Dresden Nuclear Power Station, Units 2 and 3
Facility Operating License Nos. DPR-19 and DPR-25
NRC Docket Nos. 50-237 and 50-249

Subject: Additional Information Regarding the Request for License Amendment Related to Heavy Loads Handling

Attachment
Additional Information Regarding Request for License Amendment Related to
Heavy Loads Handling

Figure A-1 Idealized Load Drop Case Considered

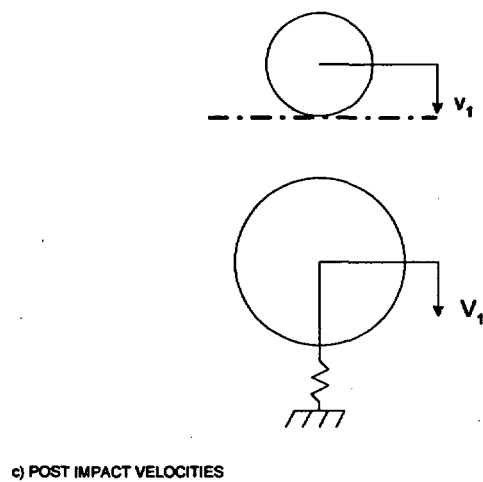
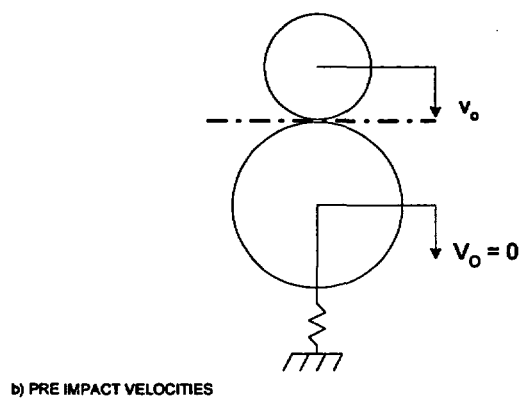
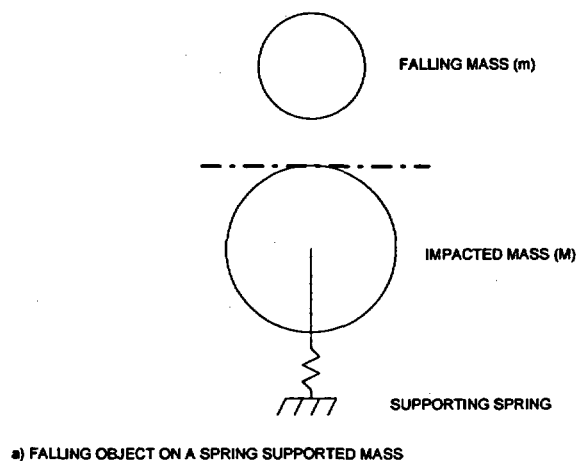
Methodology number 7 on page 6 of Calculation No. DRE02-0064, Rev. 0, states that: "The impact energy to be absorbed by the overall deflection of the impacted structural elements is less than the total kinetic energy of load drop. Some kinetic energy is dissipated during the impact. This loss, which can be computed by equating the momentum of the entire system before and after impact, is most conveniently taken into account by multiplying the available kinetic energy by a factor."

Appendix A, Section 1(7) of NUREG-0612 recommends that the analysis should postulate the "maximum damage" that could result, i.e., the analysis should consider that all energy is absorbed by the structure and/or equipment that is impacted.

Justify using lower impact energy than the total kinetic energy, which is inconsistent with the NUREG-0612 guidance.

Refer to the idealized condition shown in Figure A-1. A falling object of mass, m , drops onto a stationary mass, M , that is spring supported. Using standard impact analysis as contained in Section 13.13 of Reference 1, the ratio of the energy transmitted to the supporting spring to the pre-impact falling object energy is calculated.

Figure A-1 (a) shows the condition just before impact:

Figure A-1 (c) shows the condition of velocities of the two bodies just after impact. The post impact velocity of mass (m) is v_1 , and the post impact velocity of the mass (M) is V_1 . Using the standard analysis detailed in Reference 1, the post impact velocities are determined in terms of v_0 and a coefficient of restitution (e). The coefficient of restitution is the ratio of post impact relative velocity to the pre-impact relative velocity. In this case, the coefficient of restitution is

Note from Equations (3) and (4) that when the restitution coefficient (e) is zero, the velocities V_1 and v_1 are equal, and the two masses move together. This is the so called condition of plastic impact. The actual value of (e) depends on the impacting material, and the way the two objects can become tangled together or forced to move together because of an external force such as weight, etc.

For plastic impact (e) is zero, and by virtue of discussion, following Equation (5), the masses M and m both are connected to the spring, and

Equation 6 will always result in energy transmitted to the spring that is less than the pre-impact kinetic energy.
